**Glenageary Gate LRD, Glenagery, Dun
Laoghaire, Co. Dublin**

Stage 1 Storm Water Audit

212178-PUNCH-XX-XX-RP-C-0002-SWA

60690914-ACM-00-00-DR-CE-10-0520

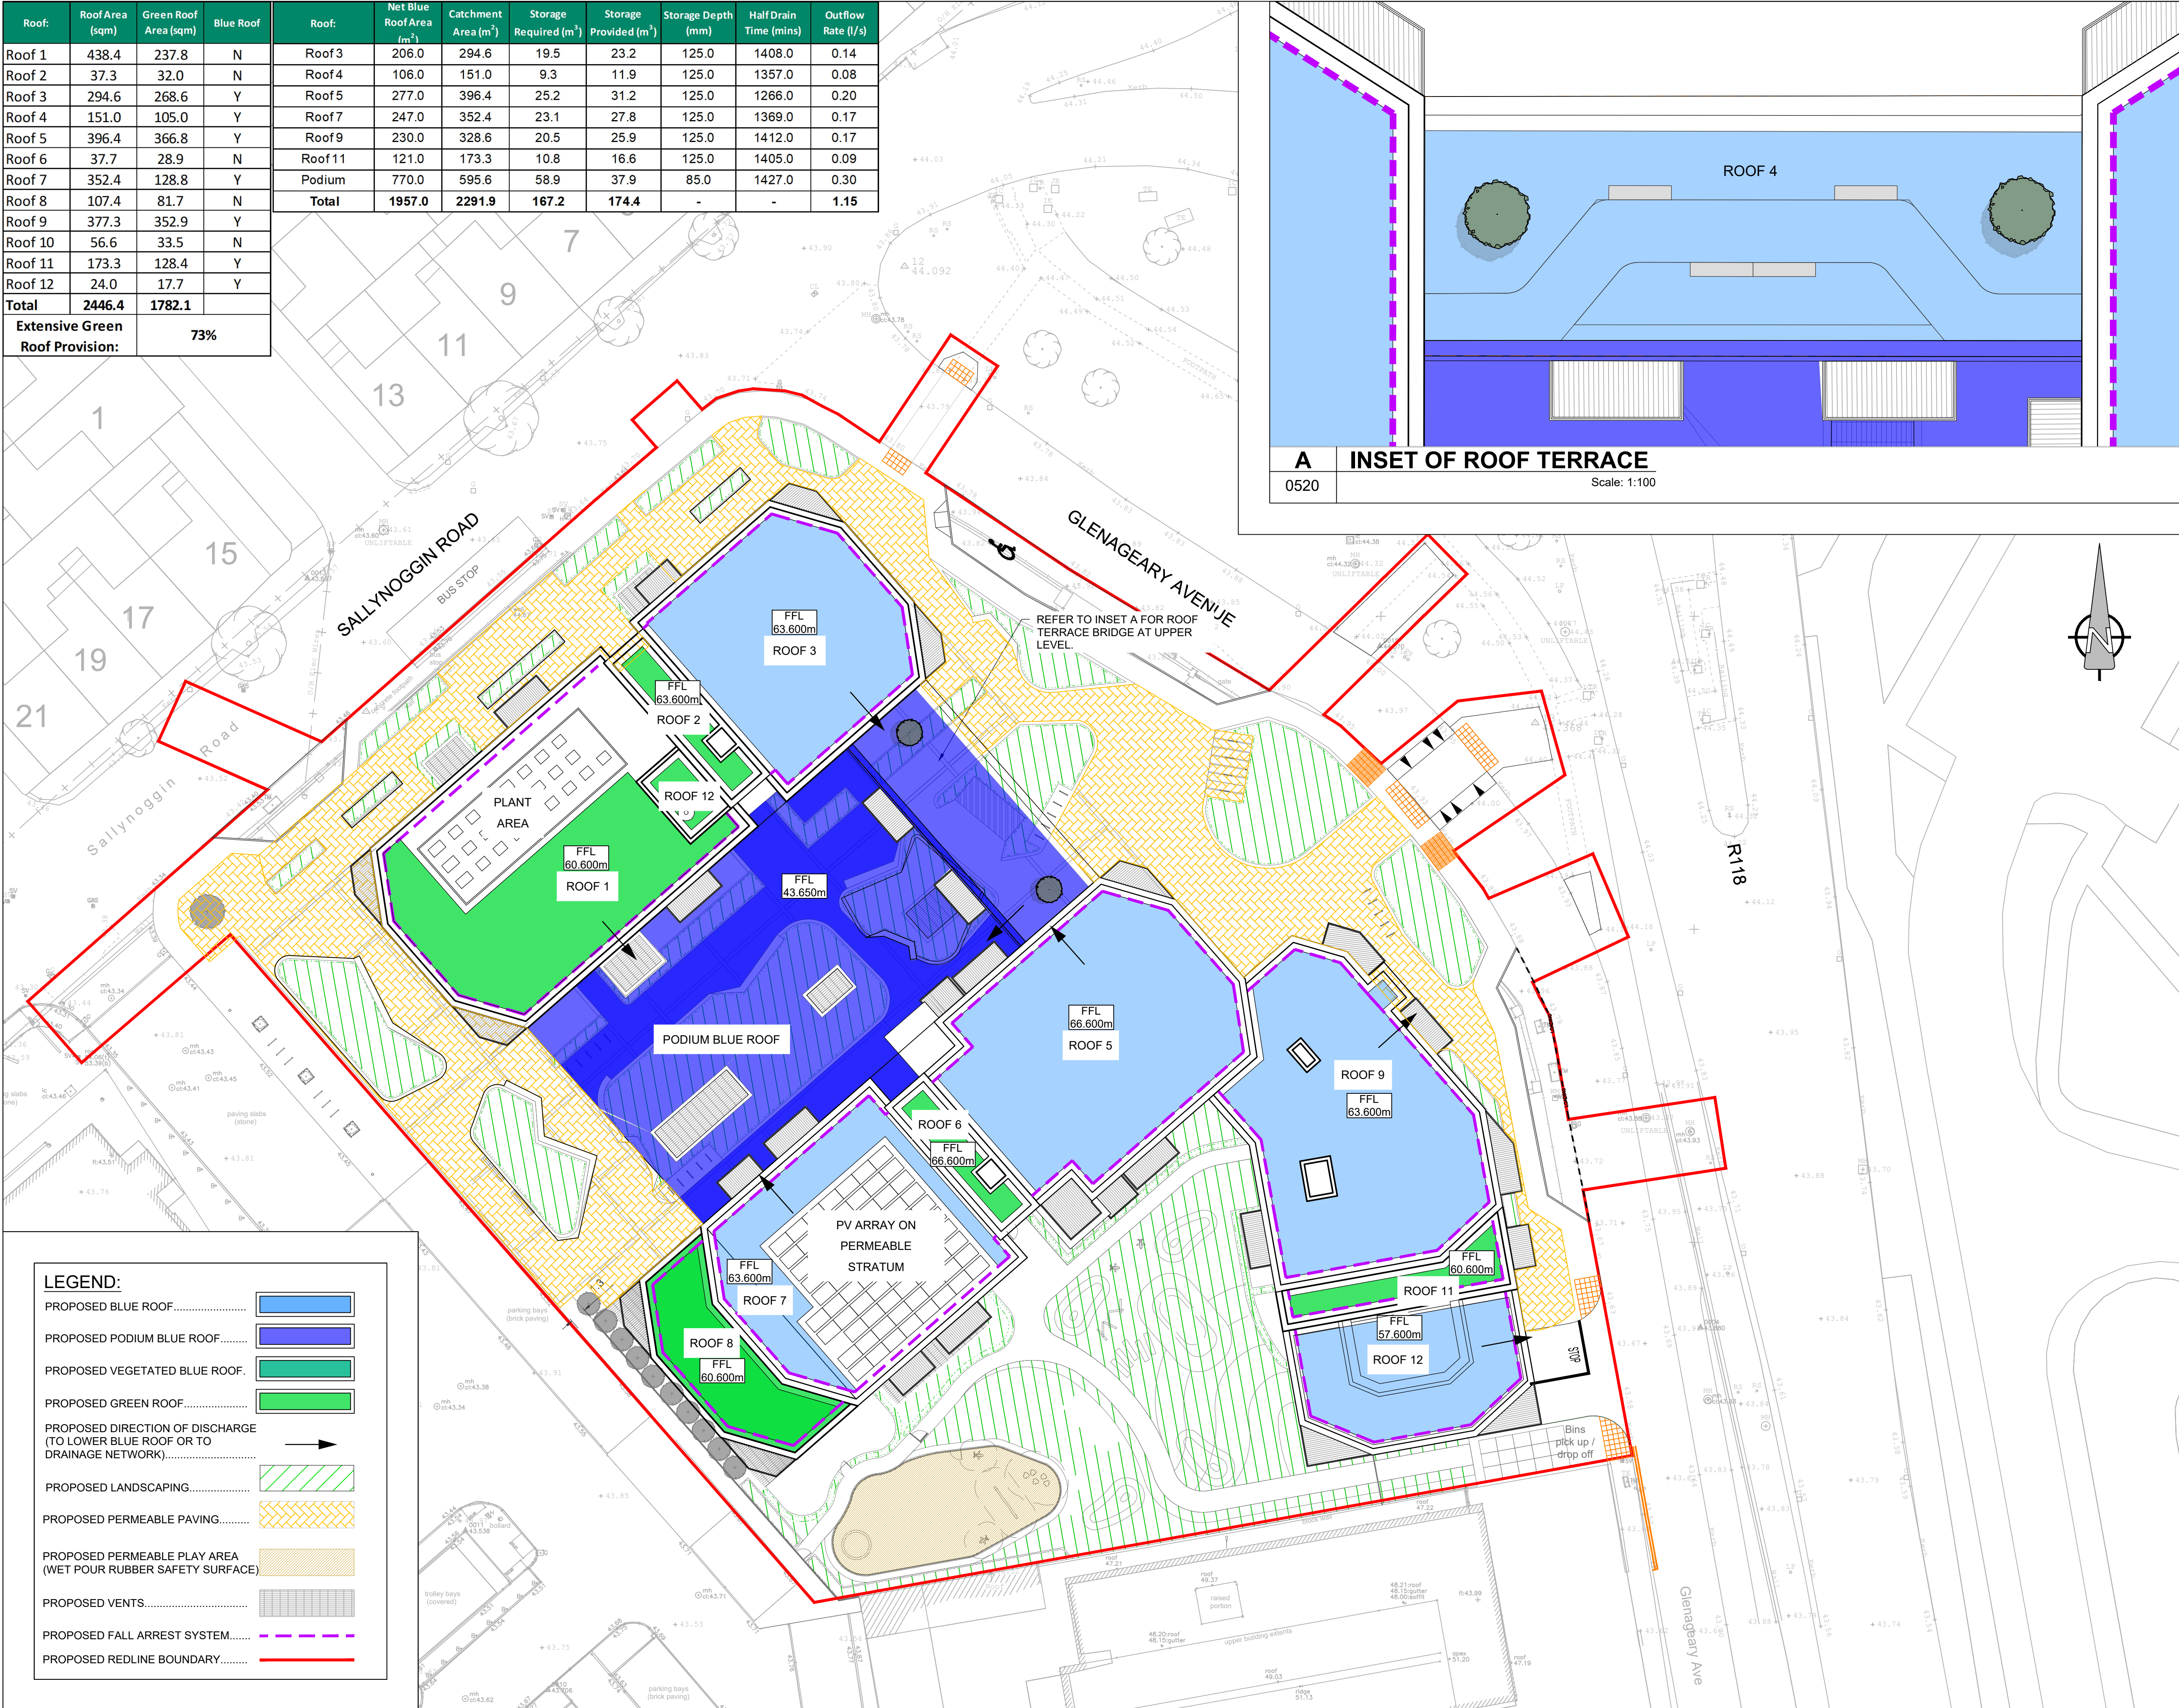
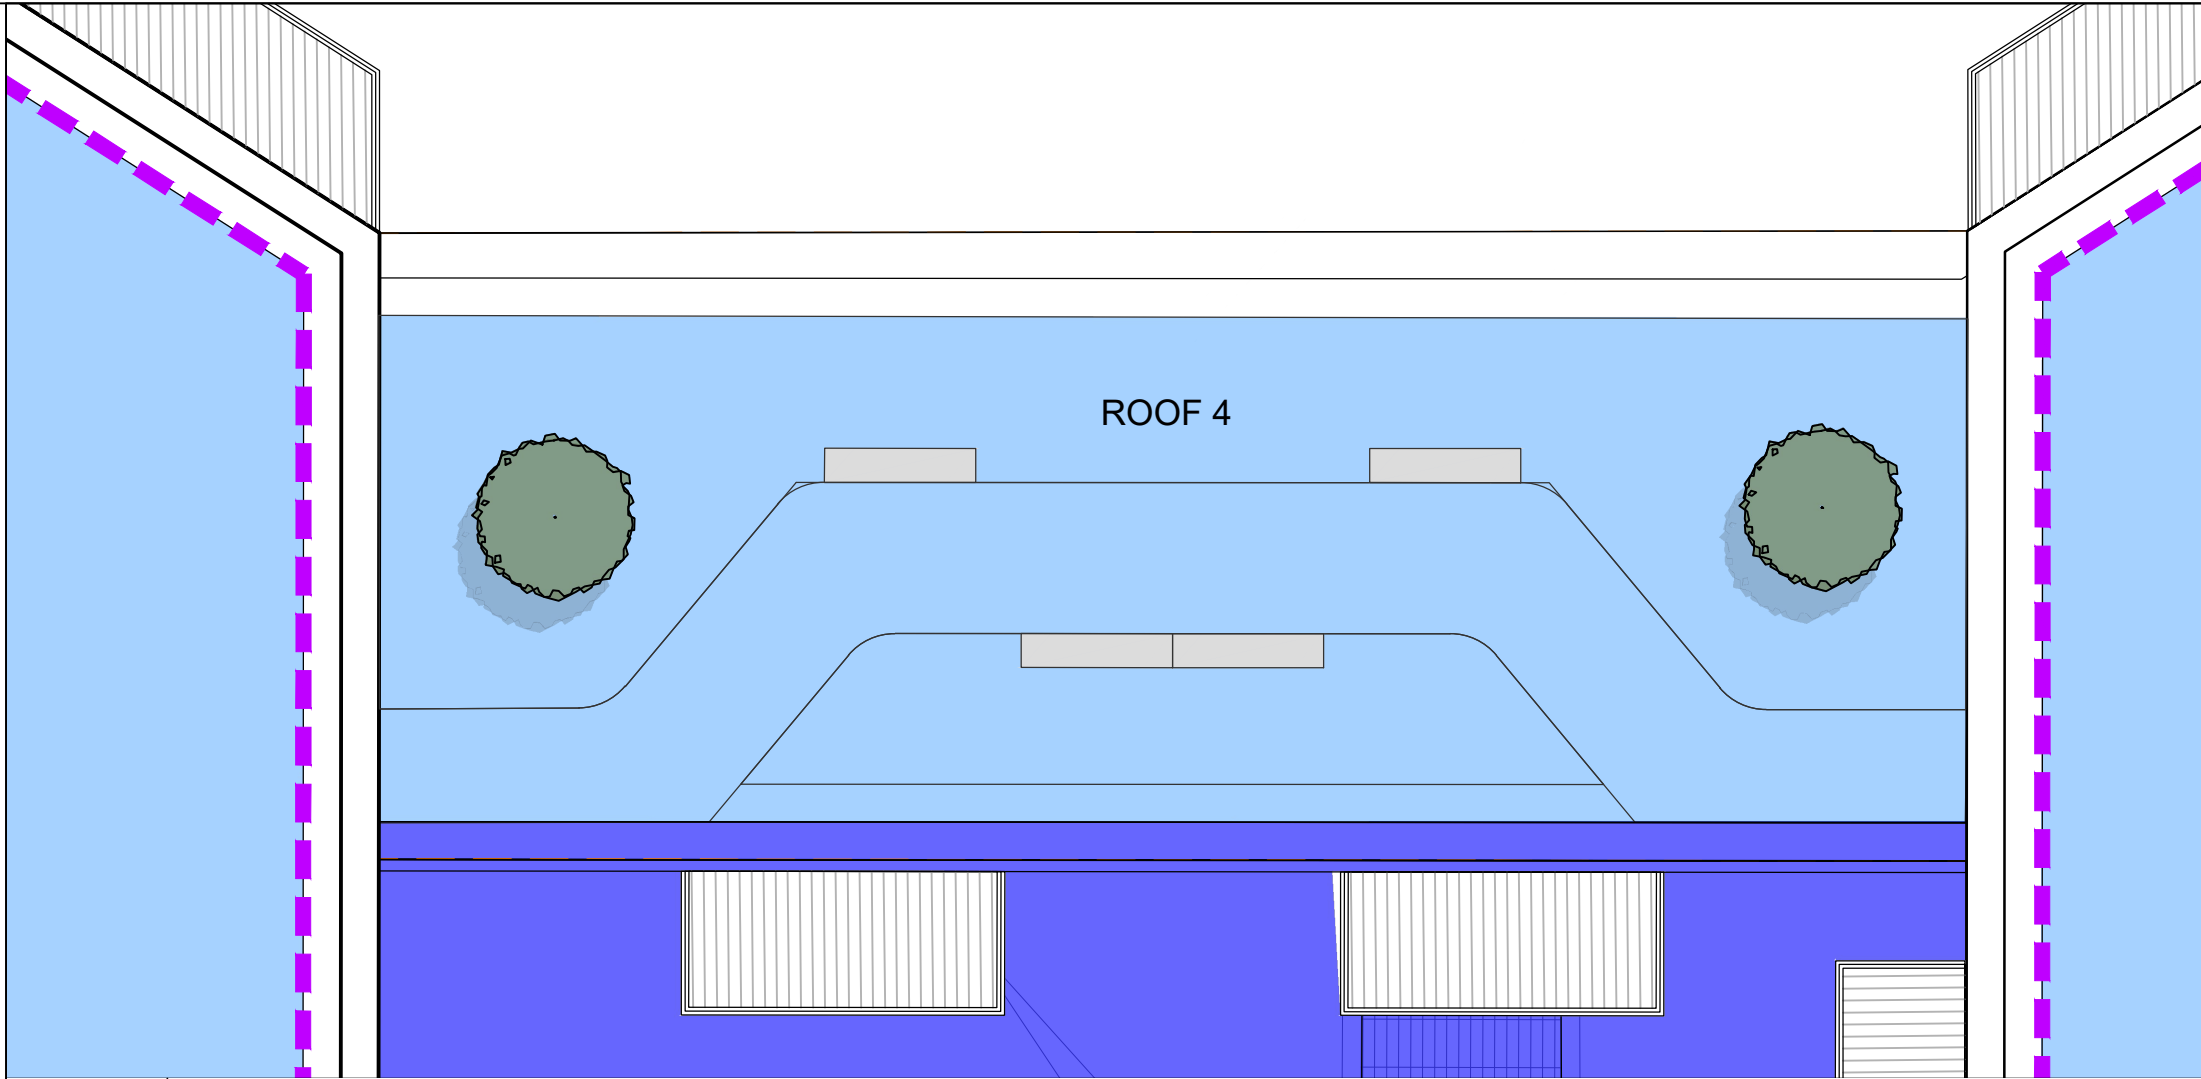
Problem: The % Extensive Green Roof Coverage on the Green Roof Provision table on drawing 60690914-ACM-00-00-DR-CE-10-0520 does not match Table 3.3 of the infrastructure report.

Recommendation: Please review the green roof provision calculations.

2.8	The % Extensive Green Roof Coverage on the Green Roof Provision table on drawing 60690914-ACM-00-00-DR-CE-10-0520 does not match Table 3.3 of the infrastructure report.	Please review the green roof provision calculations.	Please see revised drawings and Infrastructure Report	Yes
